UNIVERSITY OF MISSOURI RESEARCH REACTOR

Amendment No. 13
License No. R-103

ATTACHMENT TO LICENSE AMENDMENT NO. 13

Revise Appendix A Technical Specifications as follows:

FIGURE 6.0

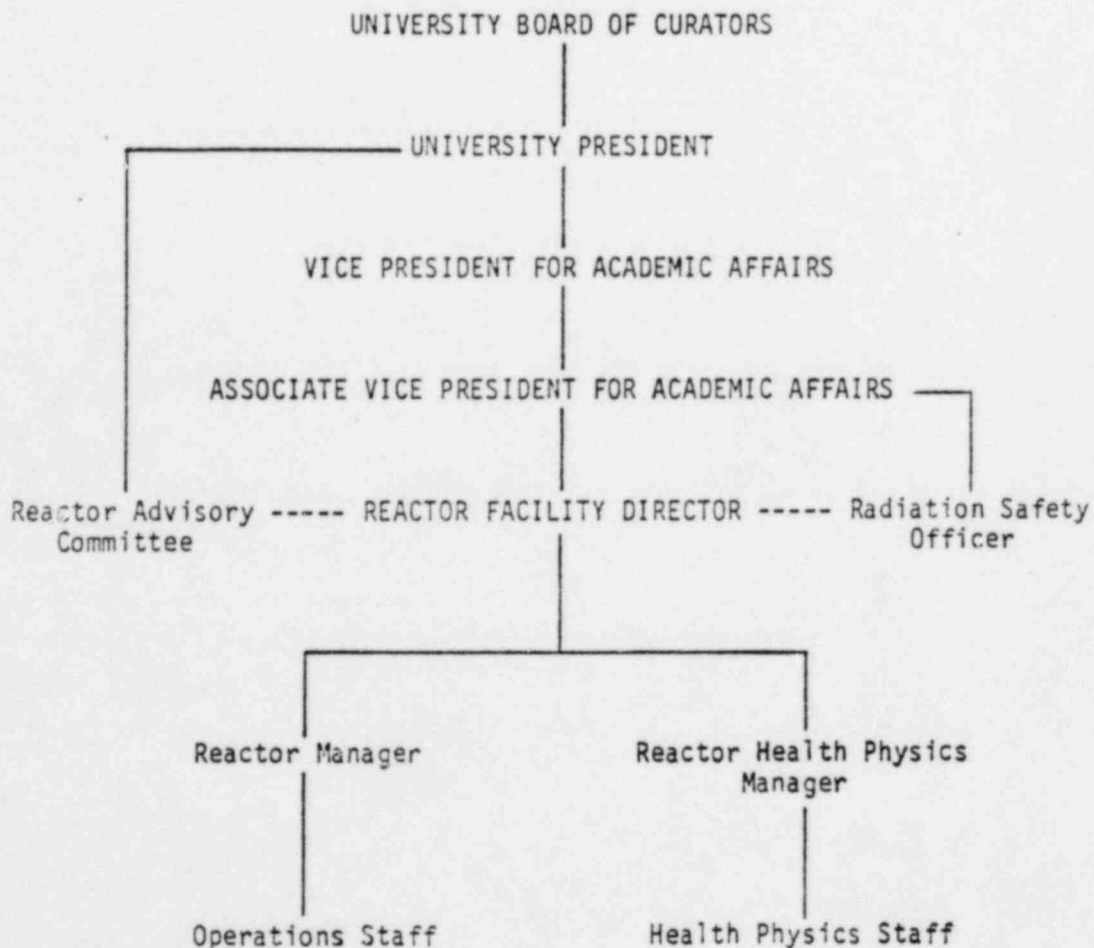
Changes on the revised pages are identified by marginal lines
